MONTGOMERY COUNTY HISTORIC PRESERVATION COMMISSION
STAFF REPORT

Address:	24 Hesketh Street, Chevy Chase	Meeting Date:	7/14/2021
Resource:	Contributing Resource Chevy Chase Village Historic District	Report Date:	7/7/2021
Applicant:	Paul Berman & Laura Dickinson	Public Notice:	6/30/2021
Review:	Historic Area Work Permit	Tax Credit:	n/a
Case Number:	955412	Staff:	Dan Bruechert
Proposal:	Window Replacement

PROPOSAL

WINDOW SIZE MARK-UP - 2021.06.25

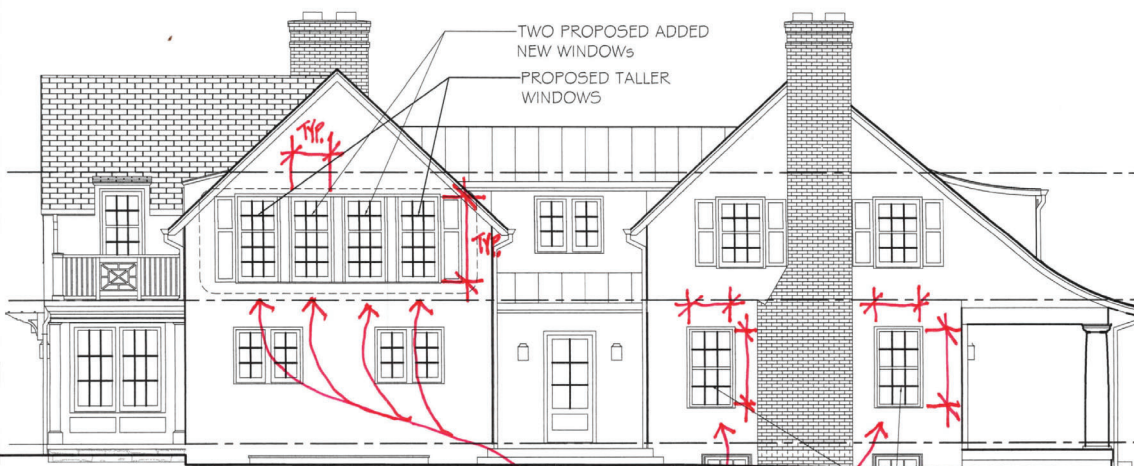
There are two fixed, six lite windows on either side of the historic chimney on the left side of the house. The windows measure 1' 10" × 3' 6" (one foot, ten inches, by three feet, six inches). The applicant proposes to remove these windows and install larger six-over-six sash windows measuring 2' 10" × 5' (two feet, ten inches by five feet). The proposed windows will be wood, SDL windows to match the dimensions and profiles of the existing windows.

Staff finds that enlarging the two windows at the front will not significantly impact the character of the house or the surrounding district. Under a Moderate Scrutiny review, Staff recognizes that the integrity of design will be impacted by this change. However, Staff finds the house will still contribute to the character of the surrounding district after this change. Finally, Staff finds the new TDL wood windows are compatible materials and finds the configuration appropriate as there are several other six-over-six windows throughout the house. Staff finds this change is appropriate under the *Design Guidelines* and chapter 24A-8(b)(2).

OPTION #1
SAME WIDTH WINDOWS;
TALLER, W/ SHUTTERS

OPTION #2
WINDOWS SAME AS FRONT;
WIDER AND TALLER THAN EXIST.

Staff recommends that the Commission **approve** the HAWP application; under the Criteria for Issuance in Chapter 24A-8(b)(2), and (d), and the *Chevy Chase Village Historic District Guidelines*, having found that the proposal will not substantially alter the exterior features of the historic resource and is compatible in character with the district and the purposes of Chapter 24A;
